Building 3 - West Elevation

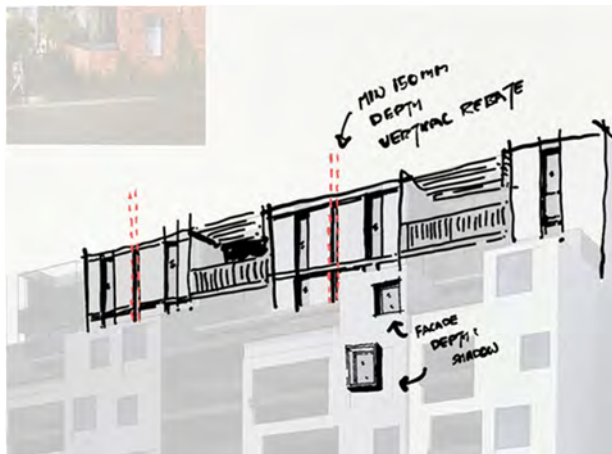
- We welcome the incorporation of lightweight balcony balustrades and trellis structures to **reduce the visual bulk of the upper setback form**. We encourage the use of climbing plants to the balcony structures to soften the building presentation.
- We also recommend minor design refinement of the upper levels to **break the horizontal massing bulk of the concrete volumes**. This may include vertical rebates within the wider concrete expressions (between the mirrored bedrooms) and horizontal expressions of the parapets and slab.
- We also recommend that the **street wall** adopts further **façade depth at window openings** to avoid a 'flat' presentation. This could also include consideration of operable external shading devices to also improve thermal performance of dwellings.

Existing 3 m Laneway – running N-S (up to Robertson Street reserve), parallel to Barnett Street

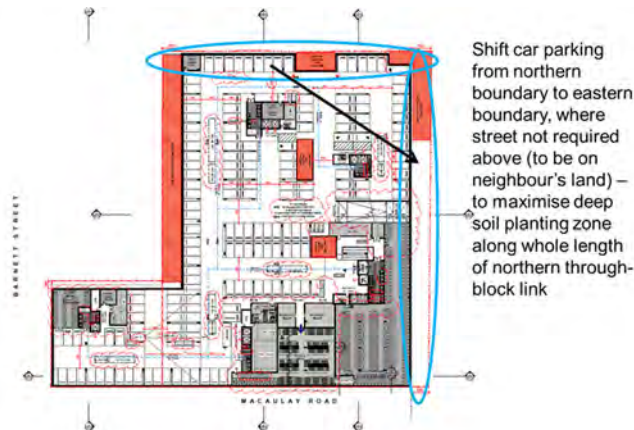
- *Widen the existing 3 m public laneway by 3 m and vest this land to Council, to enable creation of a public 6 m Laneway –Type C typology. The 3 m widening must be unencumbered both above and below ground to allow for large canopy tree planting and water sensitive urban design features.*
- *It is noted that the currently proposed development proposes a deep soil planting zone in this location, which would be able to be split between public and private ownership to enable the 6 m public laneway to be created.*

Proposed new discontinuous laneway – running N-S for three-quarters the length of the eastern property boundary

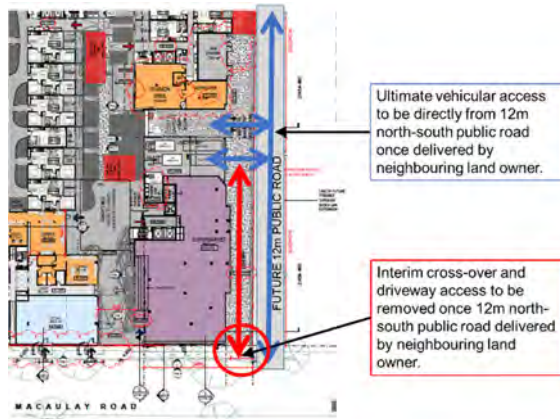
- *The developer of 402-432 Macaulay Road liaise directly with the land owner / developer of 352 Macaulay Road in regard to delivery and timing of the new 12 m public street.*

- *The development be designed and plan for ultimate future driveway access to be directly from the new 12 m public north-south street, that is to be delivered along the western boundary of the neighbouring 352 Macaulay Road site.*

- *The cross-over and vehicular driveway access from Macaulay Road be interim, until such time that the 12 m public north-south street is delivered at 352 Macaulay Road. At such time, the Macaulay Road public footpath cross-over and direct driveway access to Macaulay Road should be removed, with vehicular access to be directly from the new 12 m north-south street.*

- *The developer consider how the area of land for an interim driveway may transition in the future to be of a use other than a vehicular driveway, and how that use may interface with and activate the future 12 m north-south street, including through the addition of built form, noting its key activity centre location.*

Figure 22 - DDO63 Setback line depicted on Buildings A, C & D. From Drawing TP07.01.

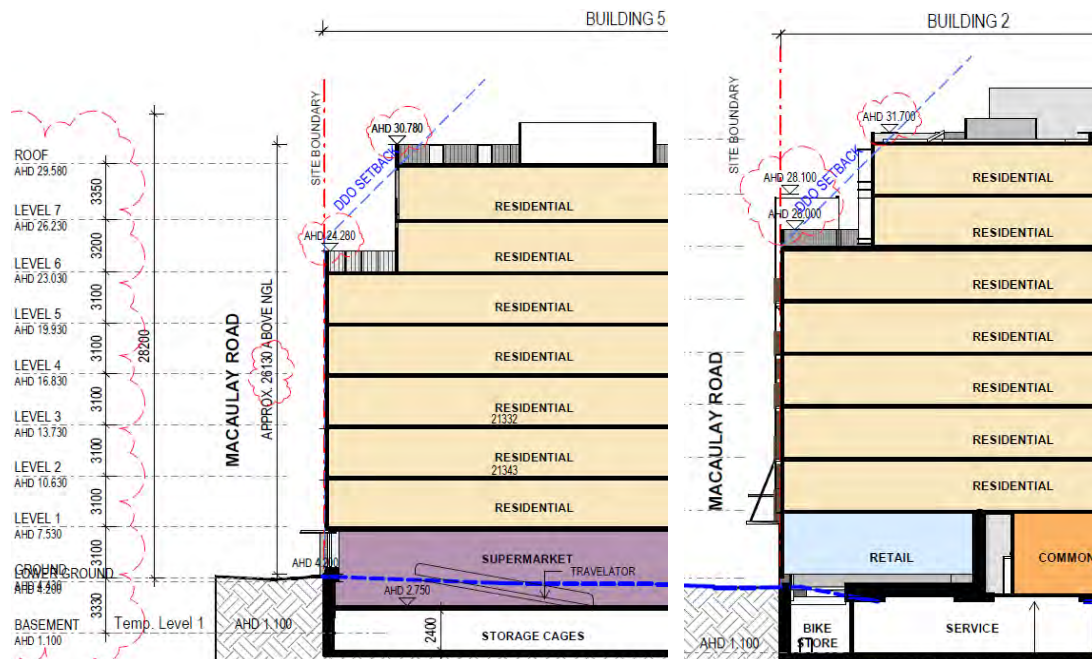
In terms of the upper level setbacks, the abovementioned buildings are set back between 4.3 and 4.55 metres above level 5 (approximately 20 metres above street level). Given the height, at street level, of up to 26.2 metres, the uppermost parts of the buildings would need to be set back up to 6.2 metres from Macaulay Road.

The extent of non-compliance with the preferred setback is illustrated in the sections at Figure 22.

Figure 24 - Marked up Section 5 depicting setback of Building 1 from the Council Laneway

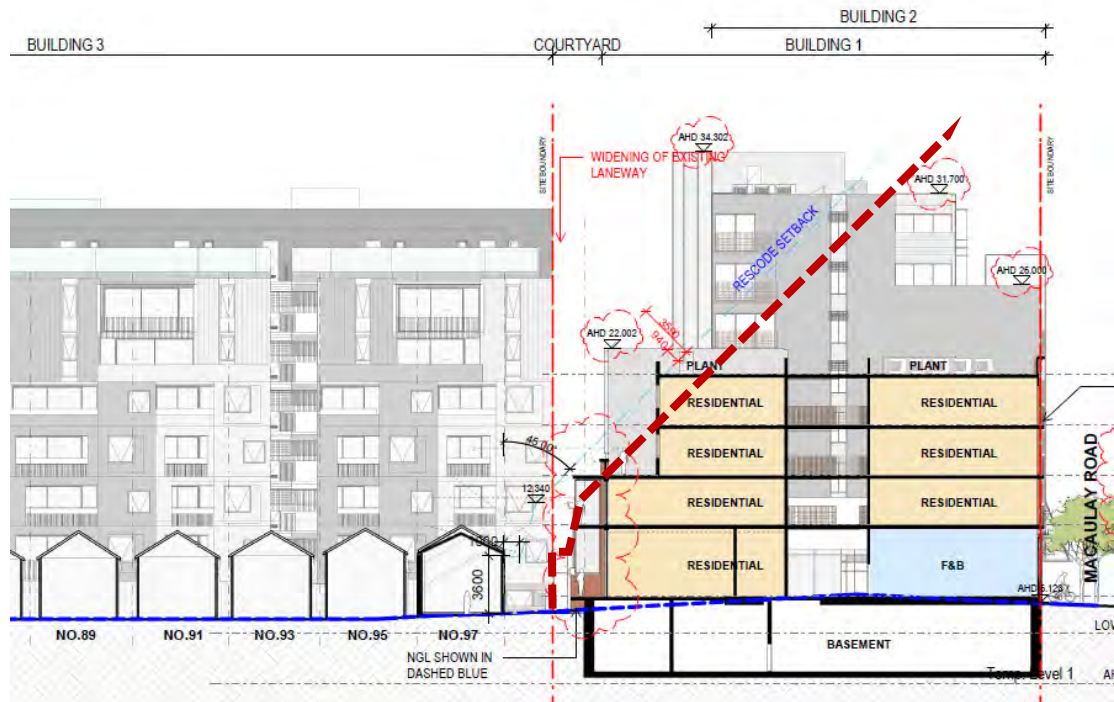
As depicted in Figures 24 & 25 (by a blue dashed line), the proposal would generally comply with the setback requirements if measured from the opposite side of the laneway. The permit applicant has argued that measuring the setback in such a manner is accepted practice at VCAT. Although this is adopted as a reasonable approach to consider the merits of a side or rear boundary setback, it is not consistent with the requirements of Standard B17 at Clause 55.

With a building height (to the parapet) of 15.7 metres, when measured from the laneway, the top part of **Building 1** should be set back 10.79 metres. In terms of **Building 3**, the building height (at level 6) of 21.6 metres would require a setback of 16.7 metres at such point. With setbacks of 6.7 and 13 metres respectively, neither building complies with the preferred setback requirement. The actual extent of non-compliance is depicted as a dashed *red* line at Figures 24 & 25.

Figure 31 - Marked up Ground Level Plan showing potential localised widening of the pedestrian arcade

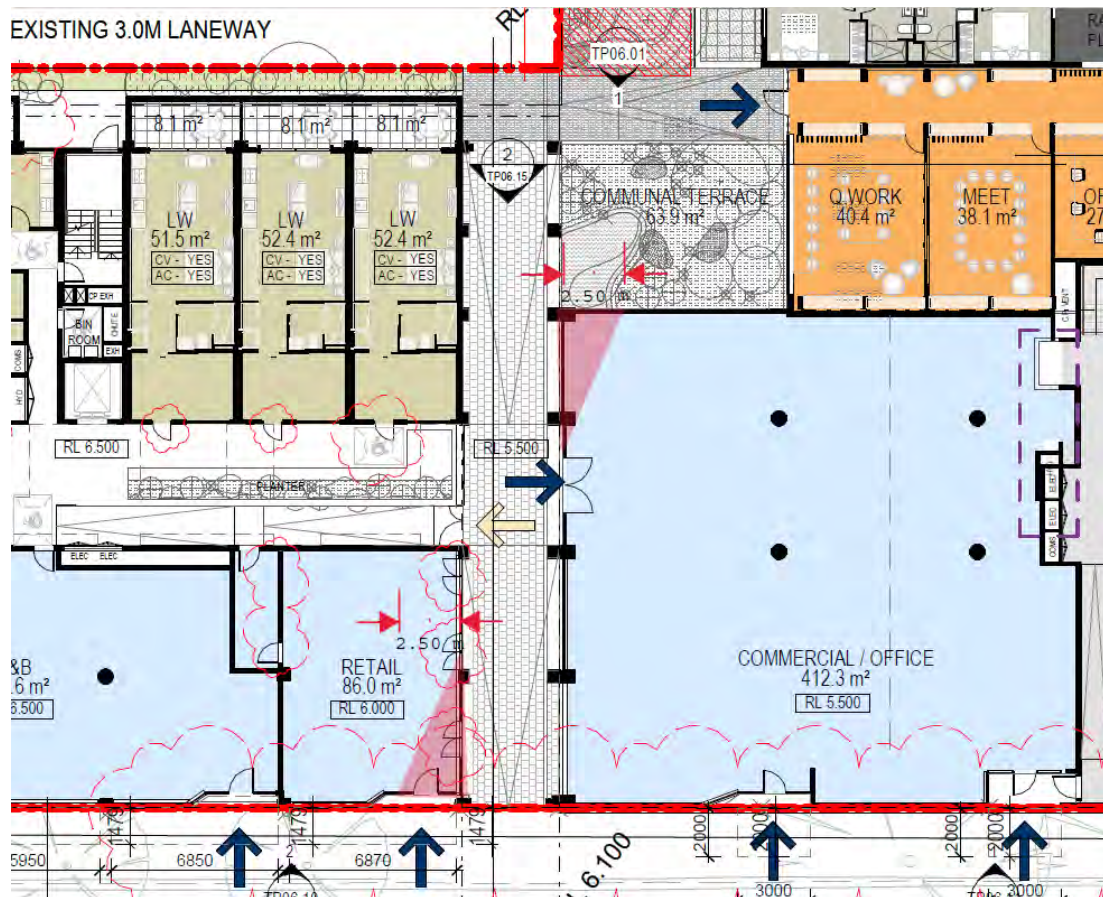
Widening of the pedestrian arcade to four metres was investigated with the permit applicant and project architect to enable more expansive views through to the Council Laneway and landscaped setback. Given the location of proposed structure, the height of the arcade and design objectives, it was considered that localised widening at either end would achieve an appropriate visual connection through to the Council Laneway.

An exact width was not agreed upon to retain a degree of flexibility, though a condition will be recommended that the widened sections would extend from the building line to the first column, as depicted in the mark-up at Figure 31.
